SERVICE BULLETIN

Document No. 159-011-00, Rev. 1
July 9, 2015

Subject: Cargo Hook enhanced safety.

Affected Hook P/N: 528-023-00

Step 3

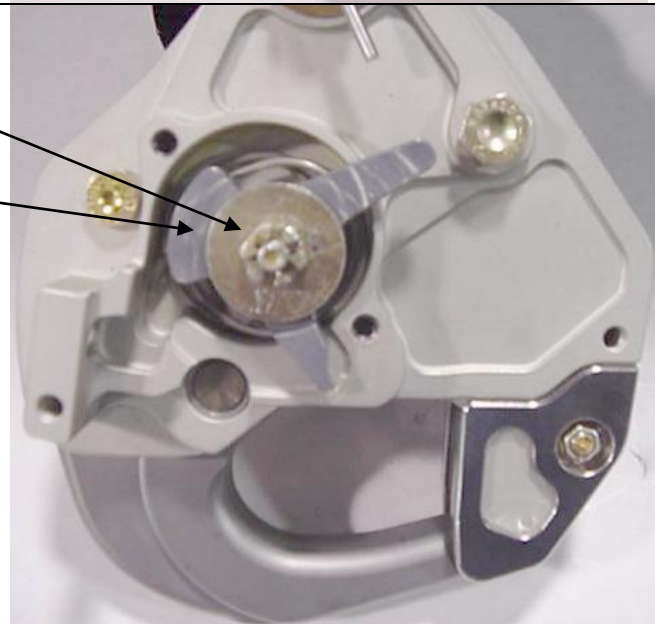
Step 2 allows access to head of this bolt.

Step 4

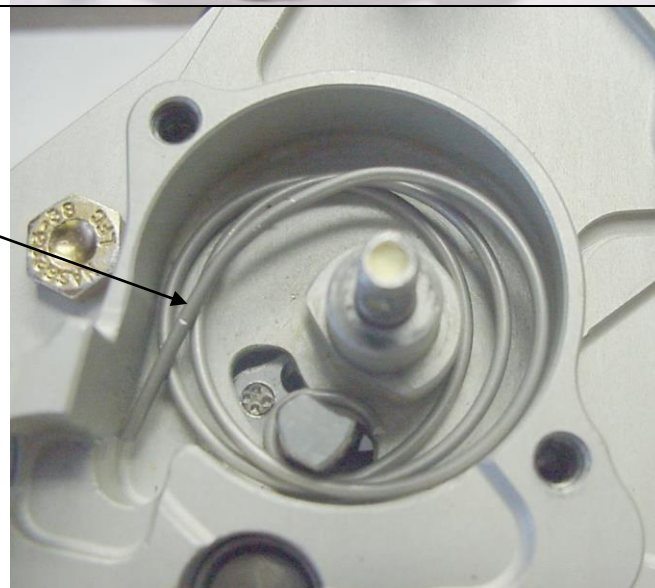
Remove cotter pin, nut, and washer from bolt.

Then remove manual release lever.

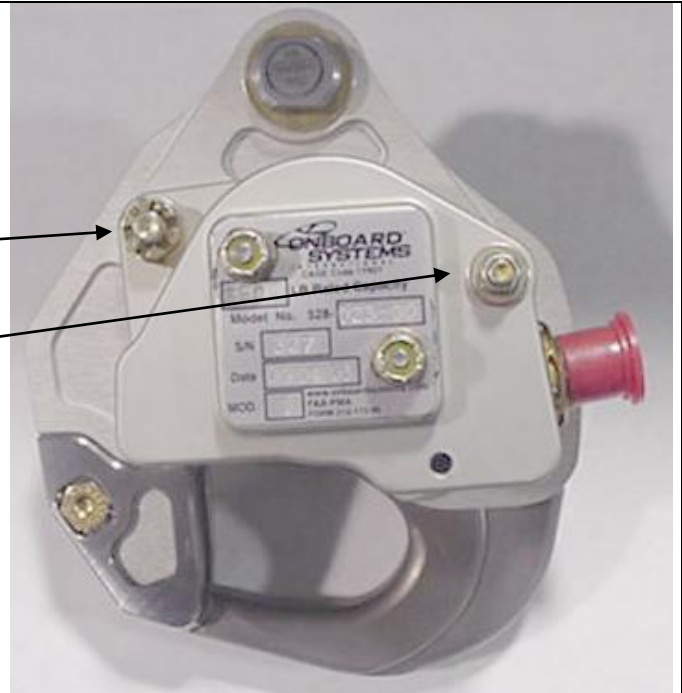
<p>Step 6</p> <p>Insert new spring assembly, into side plate pocket.</p>	
<p>Step 7</p> <p>Apply gentle pressure over and in to insert spring assembly into pocket.</p>	
<p>Step 8</p> <p>Spring assembly should fall into pocket with ease.</p>	
<p>Step 9</p> <p>Pre-load spring assembly by pulling end down within the spring cavity.</p>

Step 13

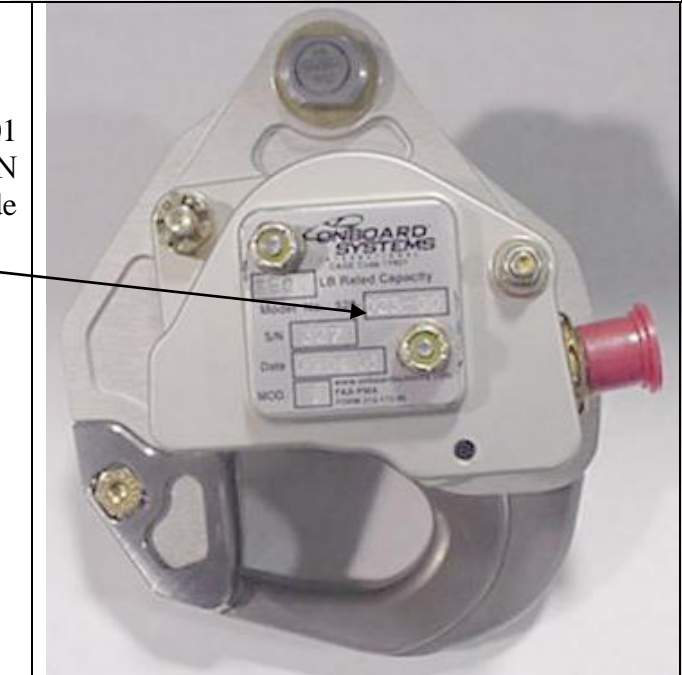
Fasten solenoid assembly onto side plate with washers, nut, and cotter pin.

Torque first nut to 15 in-lbs. and rotate to next castellation to insert cotter pin.

Torque second nut to 20-25 in-lbs.

Step 14

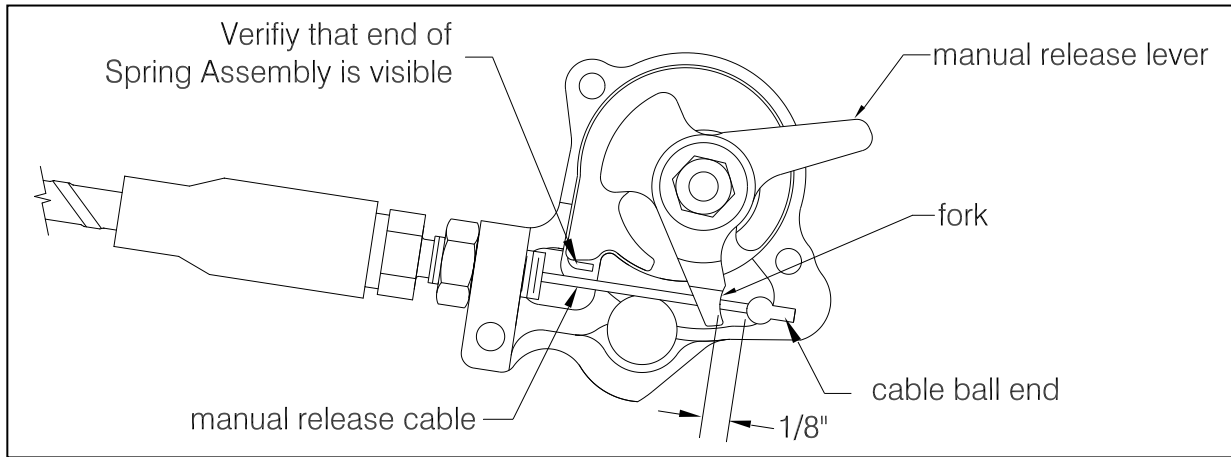
Re-identify the cargo hook as P/N 528-023-01 by steel stamping a “1” over the last 0 in the P/N on the identification plate located on the outside of the solenoid assembly.

Place the cable into the fork on the manual release lever as illustrated. Verify correct setting per the following. Move the manual release lever in the clockwise direction until free play is removed. Measure the cable ball end free play with the manual release handle in the cockpit in the non-release position. The gap should measure approximately 1/8"
